Re: JFD temeprature compensationm deviations

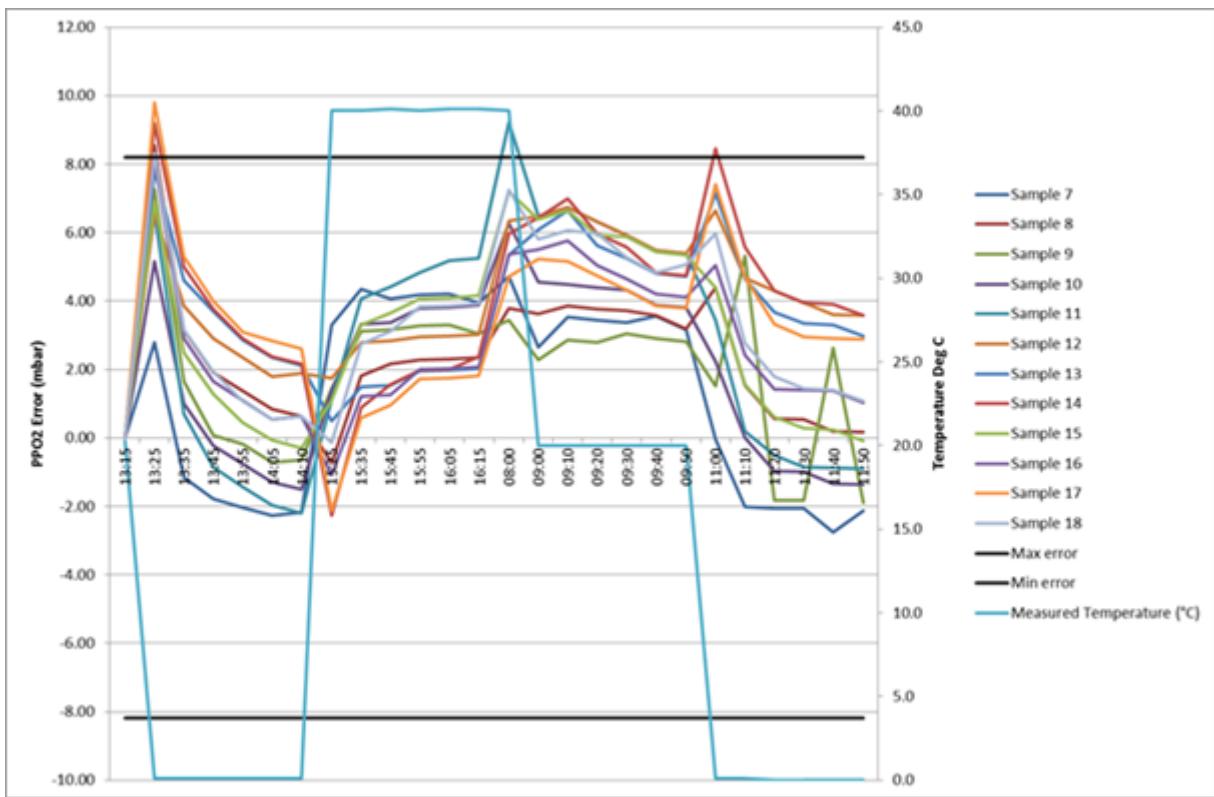
At an pO2 of 205 mbar an error of 10.25 mbar is within the tolerances. The results in your e-mail from 08.12.17 are all within that tolerances (see picture bellow).

Furthermore we specify a warm up time of 30 min. That is the time the sensors need after a sudden change in temperature to reach a stable state. The highest deviation in graph are within that stabilization period.

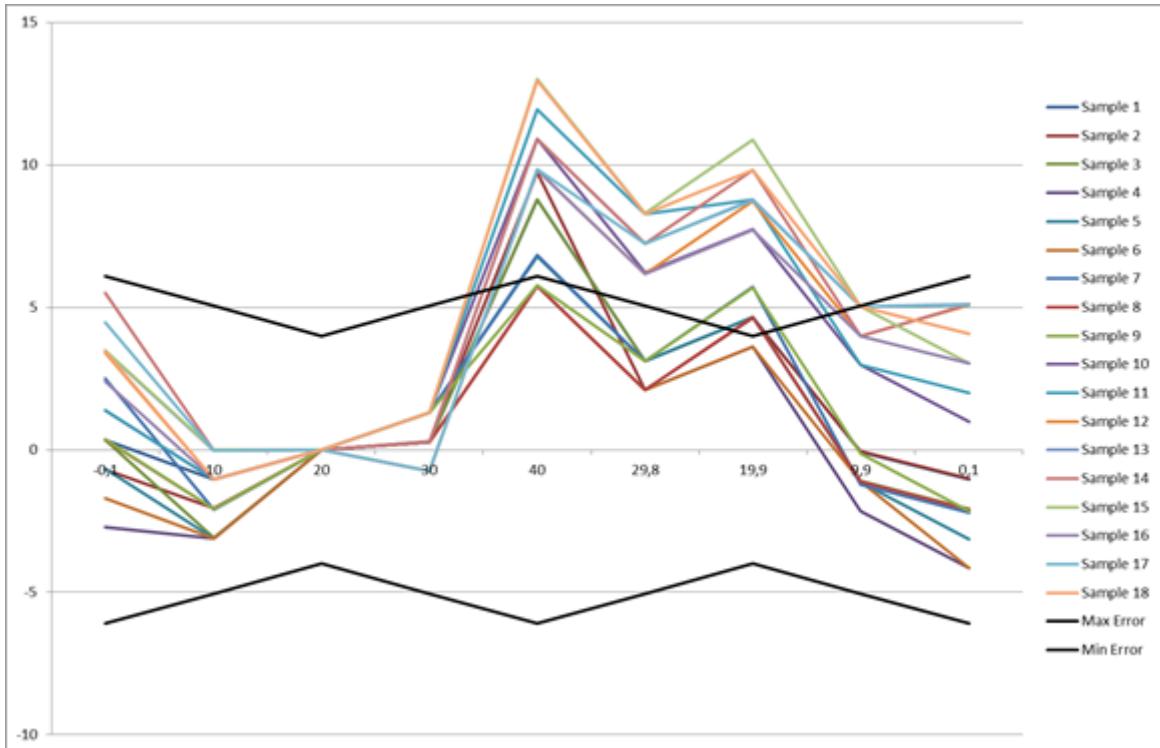
In Air (20,95% O₂) a reading from 19,95% O₂ to 21,95 % O₂ is allowed. That are again roughly 10mbar pO2 deviation at ambient pressure. So everything was in specification.

In the results with calibration board only a few points are outside the specification. It is very likely that the resistor on the calibration board interfere with our temperature compensation.

Our sensor and our end test procedure are designed to meet our specification. You can not expect sensor characteristics beyond that.
